MODEL EA12.

CIRCUIT REVISIONS

The following corrections should be made to the circuit diagram bound at the rear of this Instruction Manual. Corrections have been incorporated in Appendix "B" and also in the text where this was necessary.

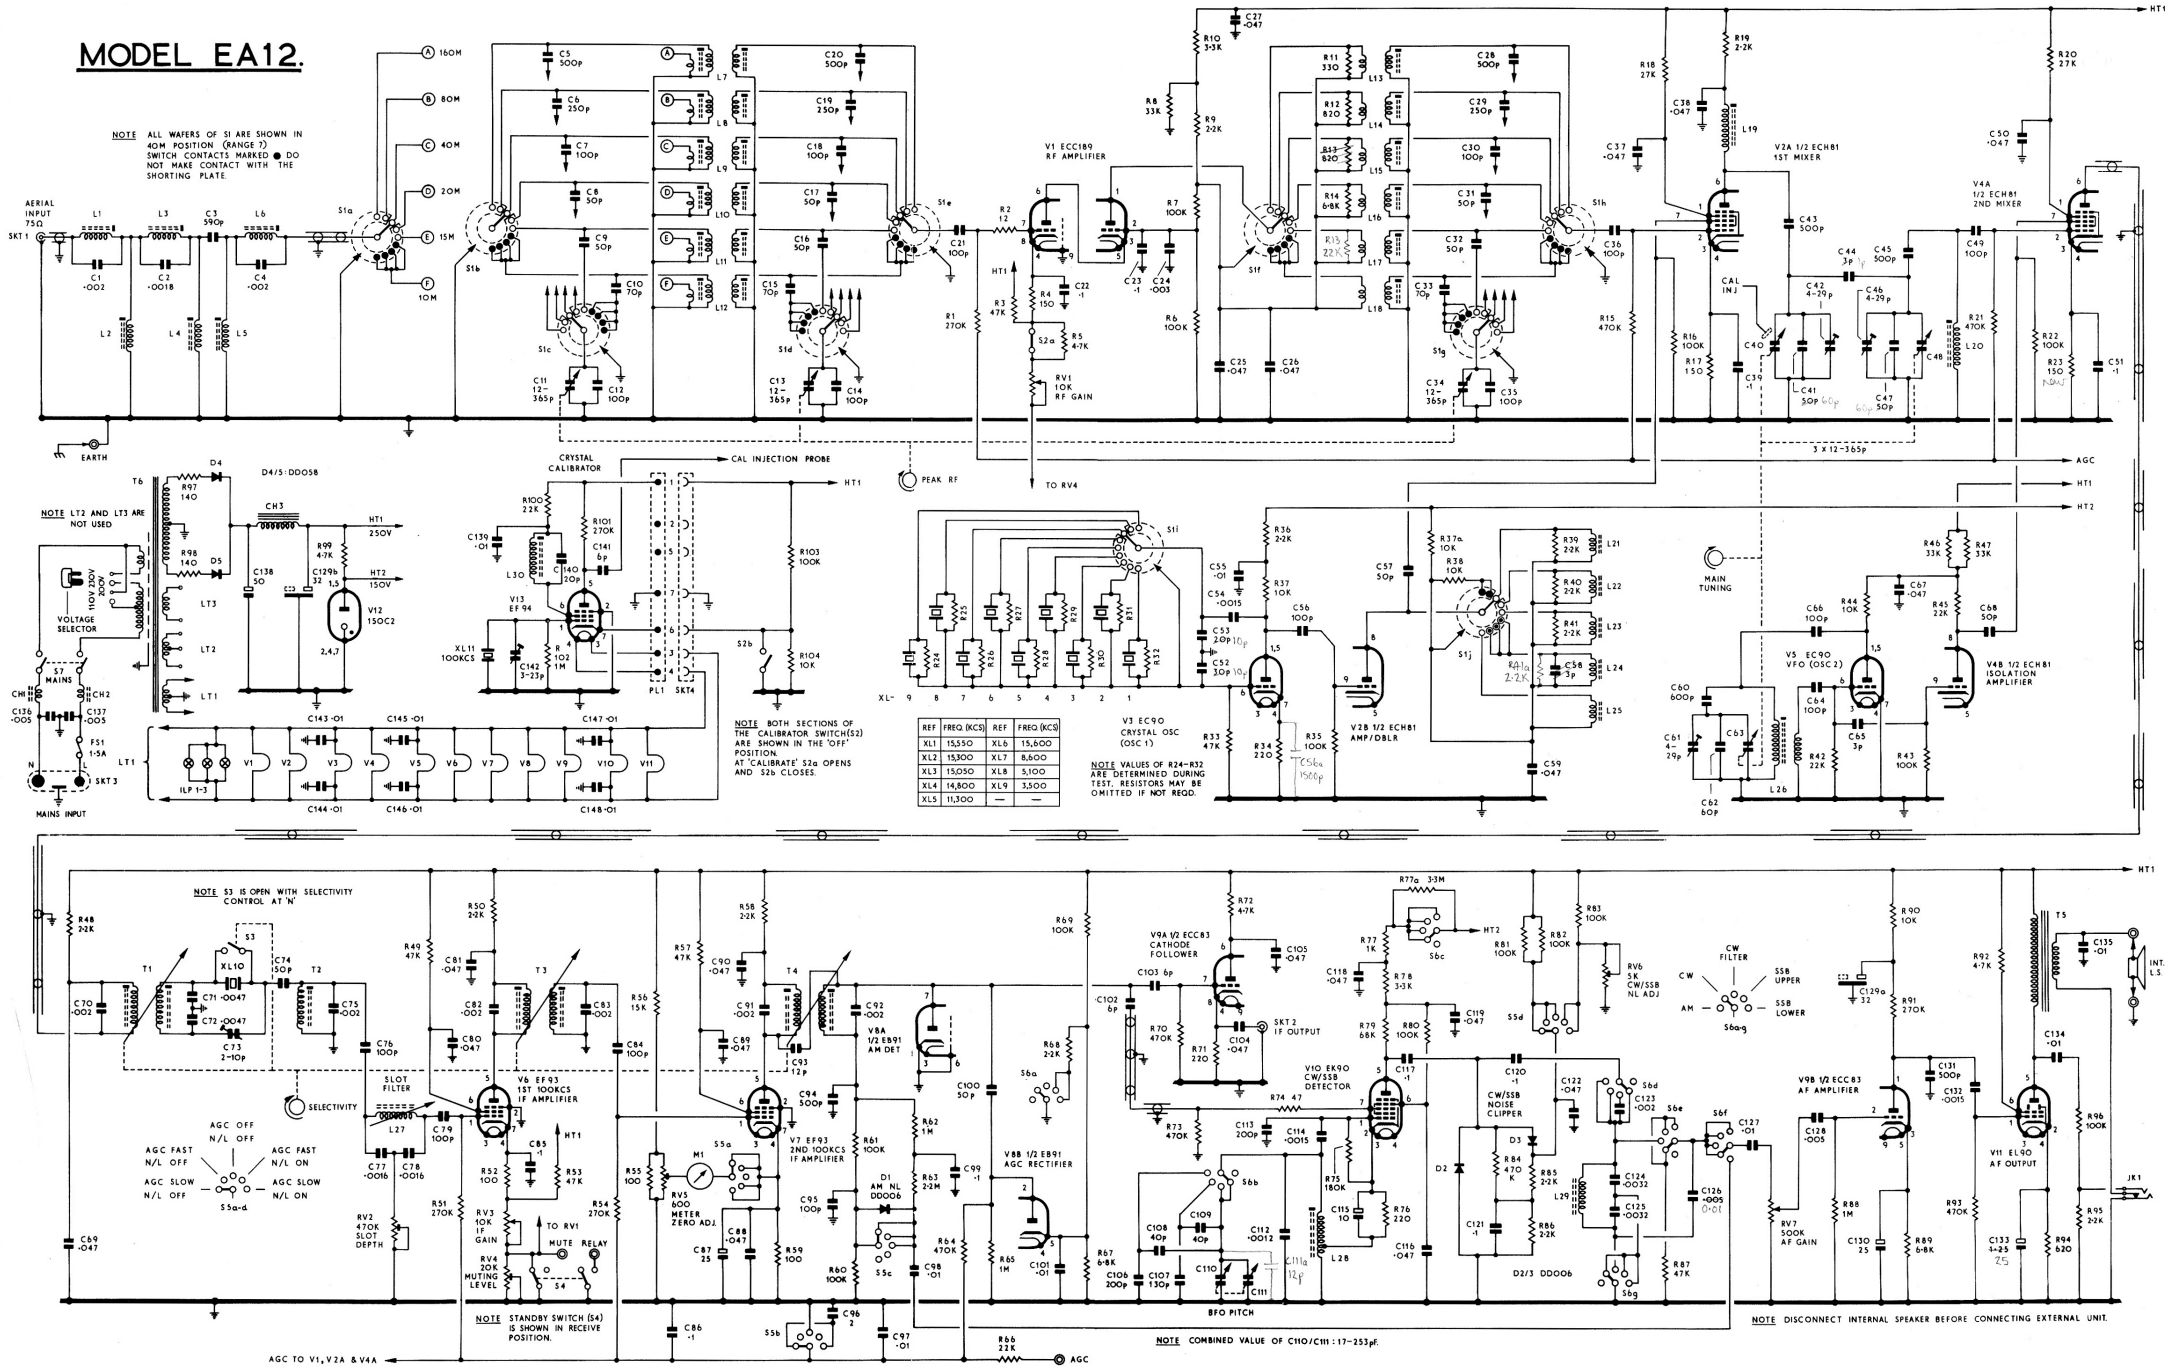
1. Change C41 to read:- "60pF."
2. Change C44 to read:- "1pF."
3. Change C47 to read:- "60pF."
4. Change C52 to read:- "10pF."
5. Change C53 to read:- "10pF."
6. Add:- "C56a 1500pF" connected in parallel with R34.
7. Delete:- "C58." Substitute a "2.2K" resistor in its place (i.e. as on L21, L22 and L23). Allocate reference "R41a" to this resistor.
8. Add:- "C111a 12pF" connected in parallel with C110/C111.
9. Change C126 to read:- "0.01μF."
10. Change C133 to read:- "25μF."
11. Show R3 connected to the other side of S2a (i.e. to junction of R4/R5).
12. Transfer R13 from primary of L15 to primary of L17. Change value to:- "22K."

1. Change C41 to read:- "50pF"
2. Change C111a to read:- "20pF"
3. Add footnote reading C77 and C78 may be 1500pF.
